RE: **Lot 21 Block 1 Unit 5 Unser Cliffs SAD 227**
6905 Rimrock NW
Grading and Drainage Plan
Engineers Stamp Date 7/5/17 (D10D031)

Based upon the information provided in your submittal received 7/5/17, this plan is approved for Grading Permit. **Prior to building permit approval the following comments must be addressed.**

| | GRADING AND DRAINAGE PLAN | DATE 6-14-17 |

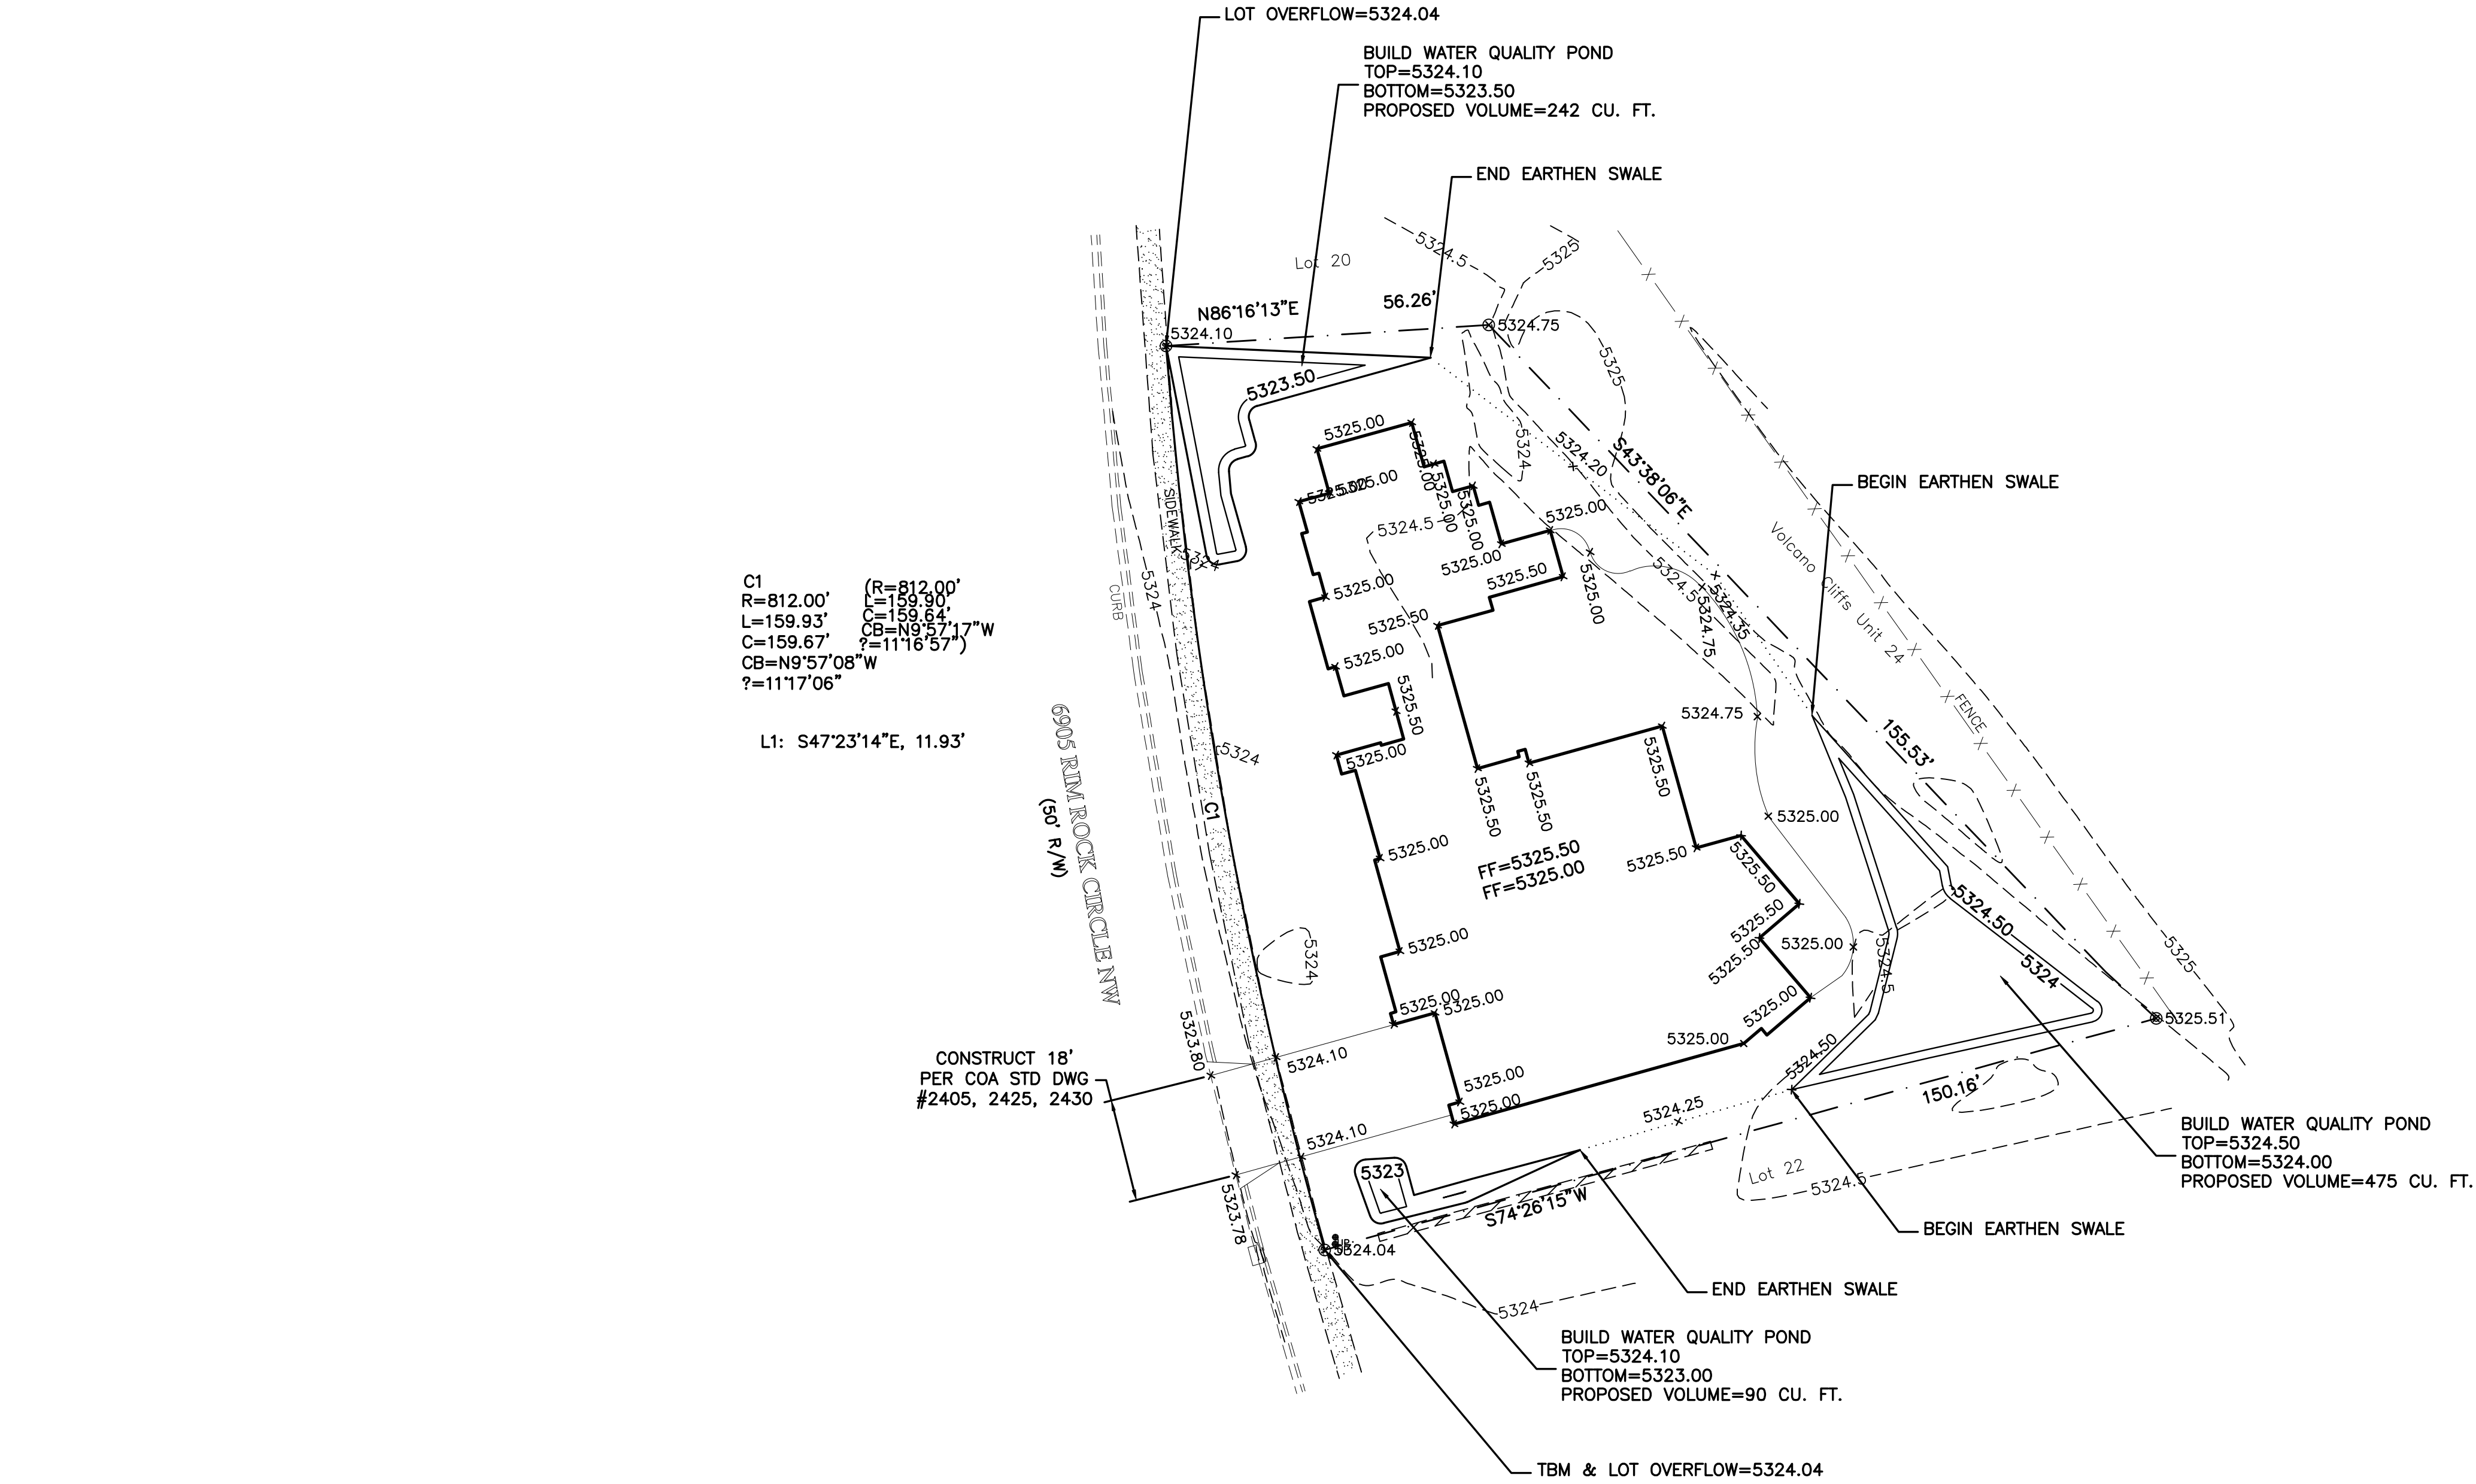
Please inform the builder/owner to attach a copy of this approved plan to the construction sets in the permitting process prior to sign-off by Hydrology. Reiterate to the Owner/Contractor that a separate permit for a garden/retaining wall must be obtained, with the approved G&D plan dated 7/5/17.

Prior to Certificate of Occupancy release, Engineer Certification per the DPM checklist of this plan will be required.
